SMYRNA HISTORIC ZONING COMMISSION

June 23, 2025

AGENDA

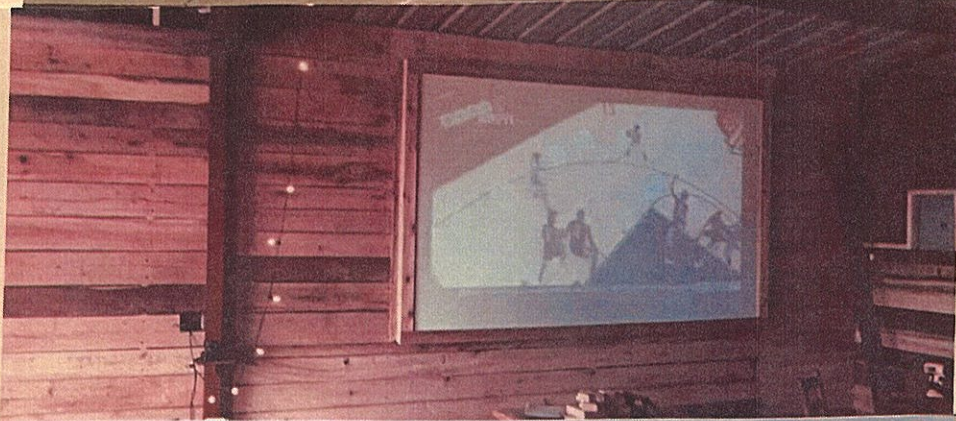
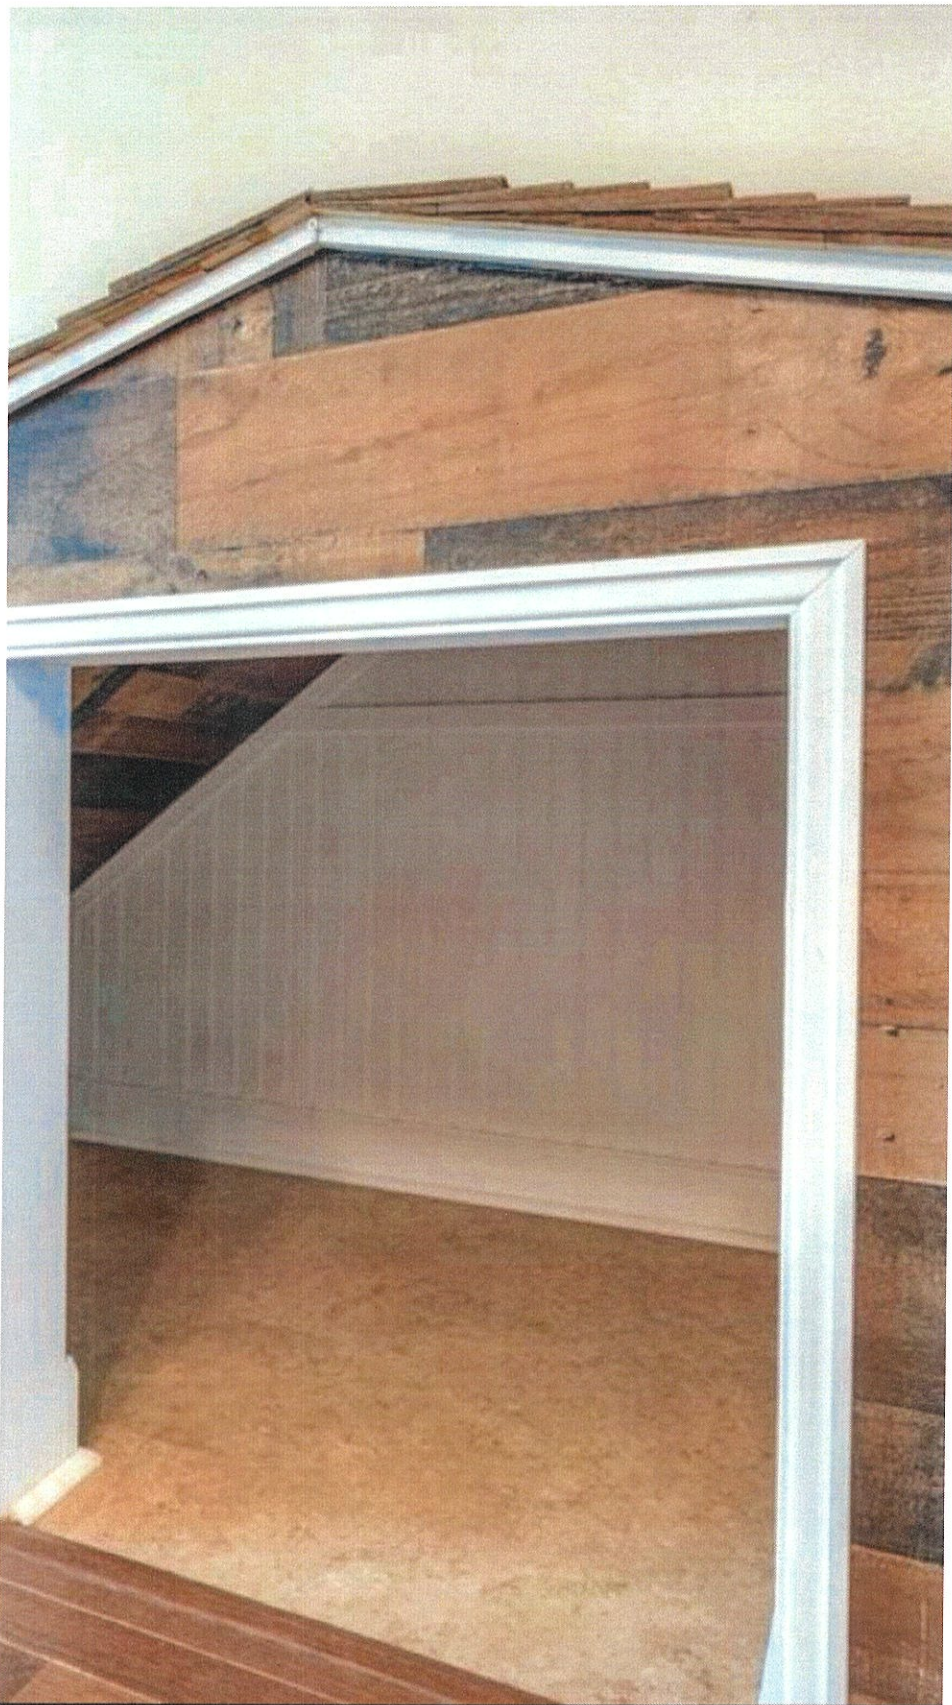
Good morning, Mitch! This is the "best" I could do for pictures requesting what we'd like to get approved for. On the pictures: 1: A) What the current front fascia currently is. The wood is rotted and shows. It's not affecting the structure. B/C) We'd like to request covering it with barn wood as shown in B/C and the other picture. It will be professionally done. At that point, we'll place our "approved" sign on the front fascia. 2) We have plans to pressure wash the outside building. I'm dropping off an actual paint swatch for approval before we paint the brick. Thank you, Mitch. Lori & Rooster Beane 615-596-1202

- b. Install barnwood siding on east and south walls - The applicant wishes to install barn wood siding. The existing wood siding on the top half of the front facade is rotted and needs repairs or replacement. The bottom half of the front facade is finished with white painted brick and glass. In addition to replacing the existing wood siding and covering the existing brick, the south wall would be clad in entirely a similar barn wood siding material. The existing south side wall is finished with cinderblock painted white.

5. Staff finds the replacement of the existing wood with barn wood and addition of barn wood may not be in harmony with Section III - Design Goals for the Front Street Historic District, 6. Deteriorated historic features shall be repaired rather than replaced. If the severity of the deterioration requires replacement of a distinctive feature, the new feature shall match the old design, color, texture, and other visual qualities, and where possible, materials. The design would change as a result of the proposed modification. Additionally, Section IV - Guidelines for Existing Buildings and Structures, A, states original materials, including masonry, wood siding and wall shingles should be retained. The addition of barn wood siding over the existing brick on the front facade and covering the existing cinderblocks on the south elevation would not be in spirit with the Ordinance.

6. Staff would recommend approval of the painting as the requested modification would meet the Front Street Historic Guidelines. The change of adding barn wood siding on the front and south facade would not be in spirit with the Front Street Historic Guidelines. Staff would recommend, if approved as presented, the brick on the front facade remain, but be painted the same color as the rear of the building "Extra White SW 7006". Additionally, from a visual perspective, if barn wood is approved for the front elevation, it may be beneficial to approve the barn wood along the southern elevation for consistency.

3 and 5 North Lowry Proposed Storefront

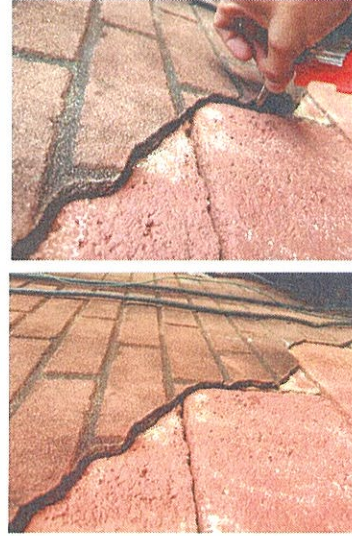
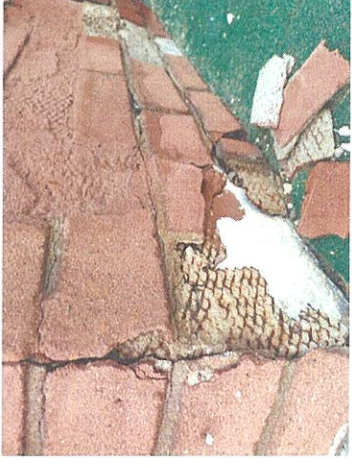
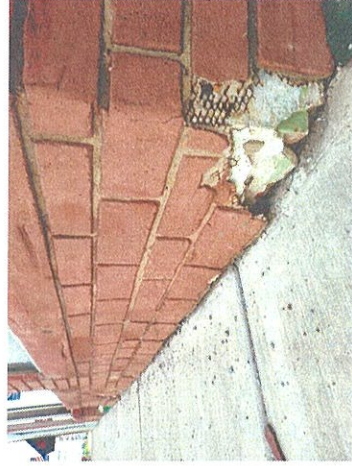
Current Storefront: Faux brick laid on top of cinder block.

Proposed Storefront: Natural wood or “wood look” lower with architectural molding and decorative columns. Top will be a darker green/ bluecolor.

- a. Install cedar planks and fiber cement board siding - The existing facade on the front of the buildings is thin brick or faux brick on top of cinderblock and concrete. Due to the deteriorating nature of the brick and ability for it to not be matched with new brick, it will have to be demolished and replaced. If replaced with new brick, the facade would extrude over the new concrete and would require additional remodeling to bring the windows and other material in line to create a uniformed appearance. With the replacement facade, the applicant wishes to install a mixture of western cedar planks on the lower half of the storefronts and fiber cement board on the top half with architectural moulding and decorative columns.

6. Staff would recommend approval of the replacement of the doors and windows using the same design and openings. Additionally, staff would recommend approval of the front facade changing from the existing thin brick to cedar wood siding as it is in line with historical photographs of the building. The mural does not meet Front Street Historic Guidelines color requirements for the exterior of a building, but does allow the Commission to deviate from requirements when fit. Other murals have been approved by the Commission over the past several years that exceeded the color allowance by the Front Street Guidelines. The change to the rear of 5 N. Lowry St. also does not meet Guidelines as the material is different from the existing product, but would retain a similar vertical design style. The appearance, as presented, would vary from any other structure in the rear along N. Lowry St. within the Historic District if approved, but would provide an updated feel.

ORIGINAL PHOTOGRAPH

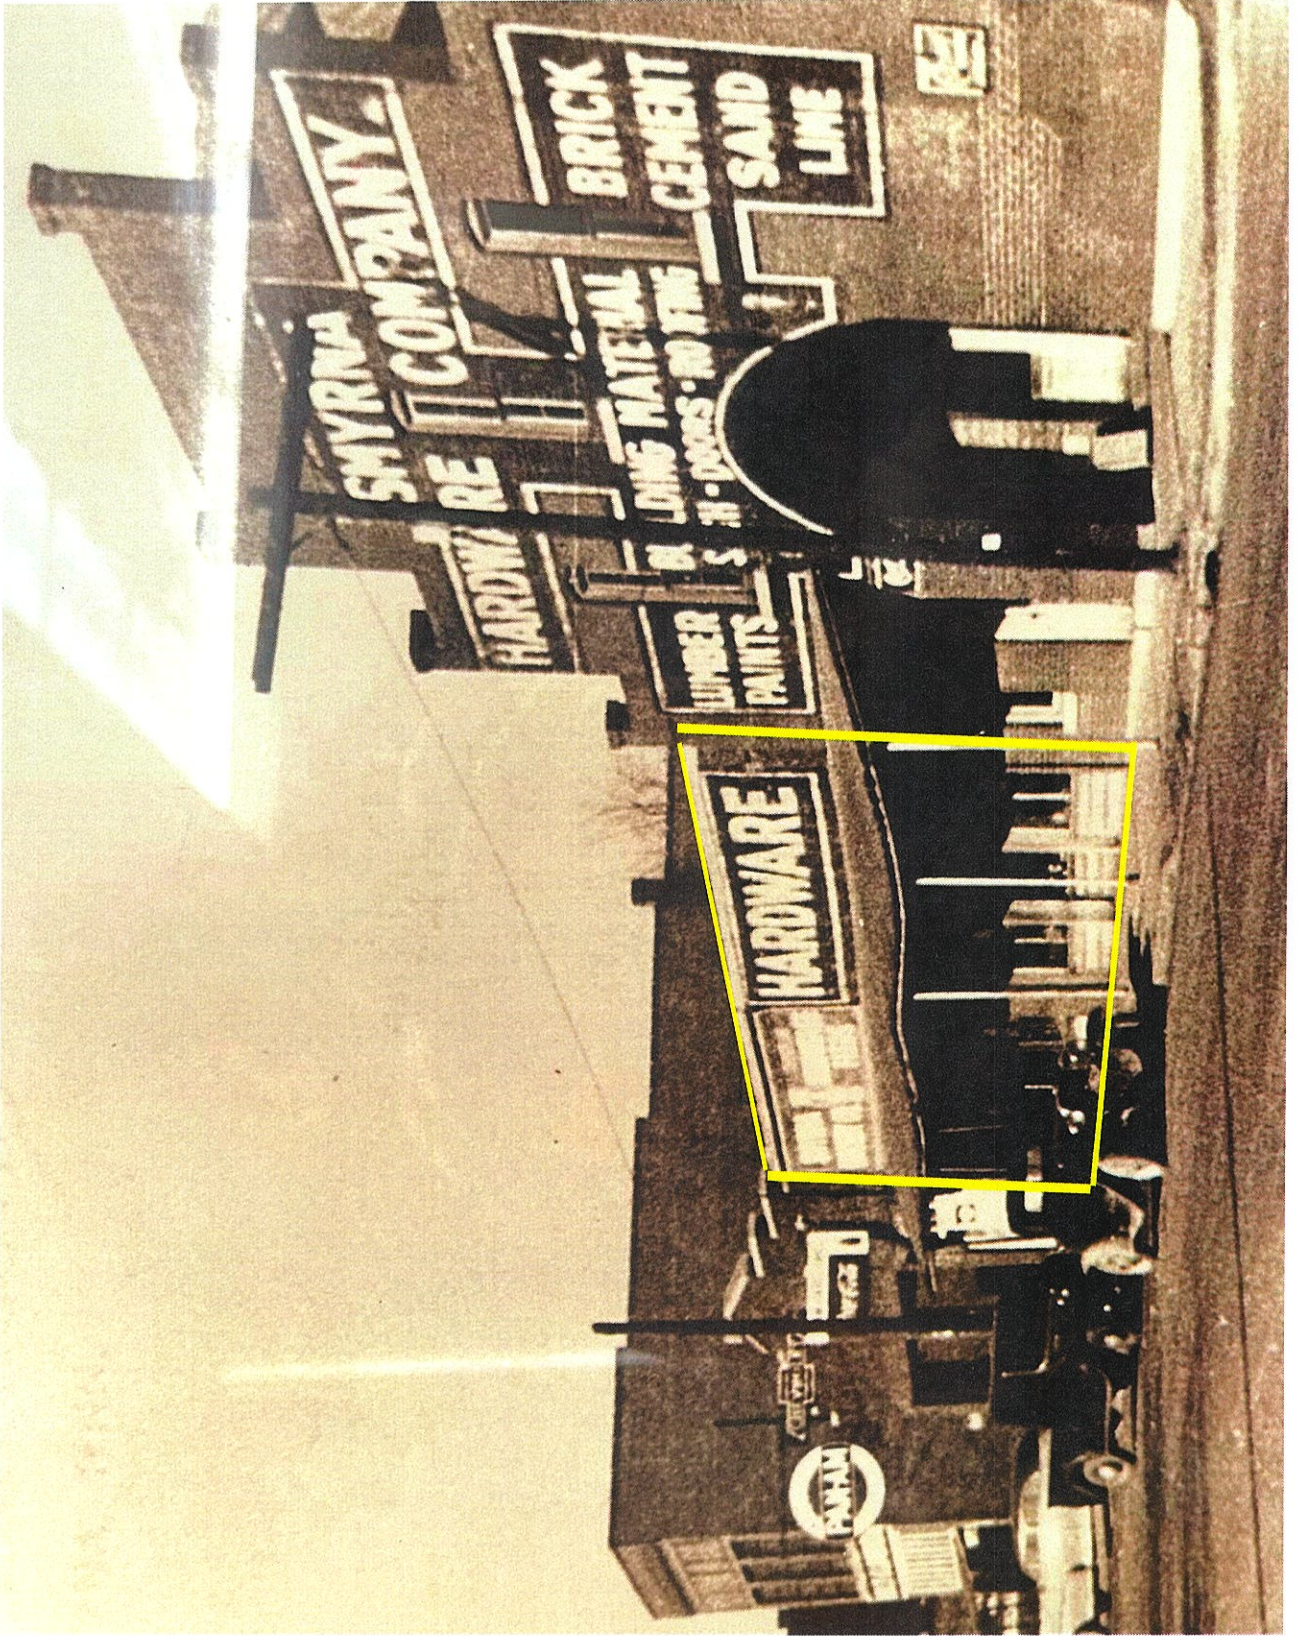
COLORES: ORANGE, GREEN, PINK, PURPLE, GRAY

- c. Mural - The applicant wishes to paint a mural on the rear south side of 5 N. Lowry Street. The following colors are proposed to be used: orange, green, pink, purple and gray, most of varying shades.

4. Staff finds that the proposed changes may not be in harmony with Sections XI - Color. Front Street Design Guidelines restricts paint colors to not exceed two separate colors on building exteriors. The colors proposed for the mural include various shades of orange, green, pink, purple and gray. Colors listed in the adopted color palette for exterior surfaces are unpainted brick, white, black (accent only), and various shades of the following colors: yellow, tan/beige, gray, brown and green. Any color not listed on the color palette is not allowed unless specifically approved by the HZC. The proposed change to the rear of 5 N. Lowry St. may also not be in harmony with Section IV - Guidelines for Existing Buildings and Structures, A.2. Guidelines state the original building materials shall be retained in the event replacement is necessary and maintain a similar appearance.

☑ Aluminum coping long end caps and inside miters.

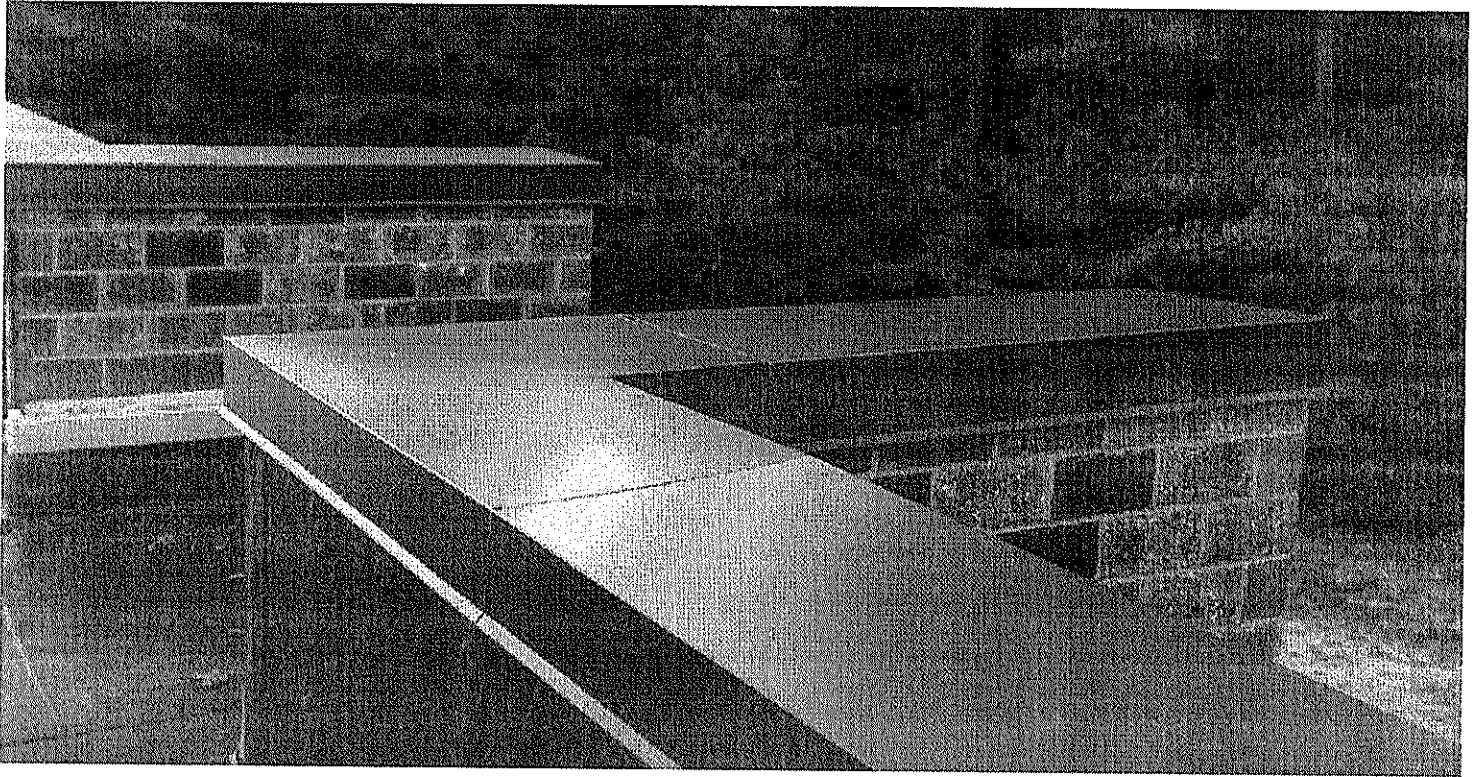
- d. Replace clay parapet - There is an existing clay parapet cap on top of the building that has been repaired and caulked several times and is still causing water intrusion issues. The applicant wishes to install a new metal cap in place of the existing clay parapet cap to prevent further water damages. The applicant will be able to replicate the color of the existing caps, but likely unable to provide a similar form.

5. Staff finds the replacement of the existing clay parapet with a metal cap may not be in harmony with Section III - Design Goals for the Front Street Historic District, 6. Deteriorated historic features shall be repaired rather than replaced. If the severity of the deterioration requires replacement of a distinctive feature, the new feature shall match the old design, color,

texture, and other visual qualities, and where possible, materials. As stated, the replacement should be clay to match the existing cap. Replacing the clay cap with metal would make for easier future maintenance efforts.

6. Staff would recommend approval of changes A-C (caulk, tuck point, elastomeric coating and painting) as the request of modifications meet the Front Street Historic Guidelines. Change D (replacing existing clay cap with metal) would not be recommended by staff as it does not meet Front Street Historic Guidelines. Due to the height of the building and position of installation of the caps, it would be difficult to decipher a difference between the existing clay caps and metal caps when kept the same color of clay. If approved as presented, staff would recommend the metal cap be a similar color to the existing clay cap and the applicant to use all efforts to keep the same shape and visual appearance as the clay caps today.
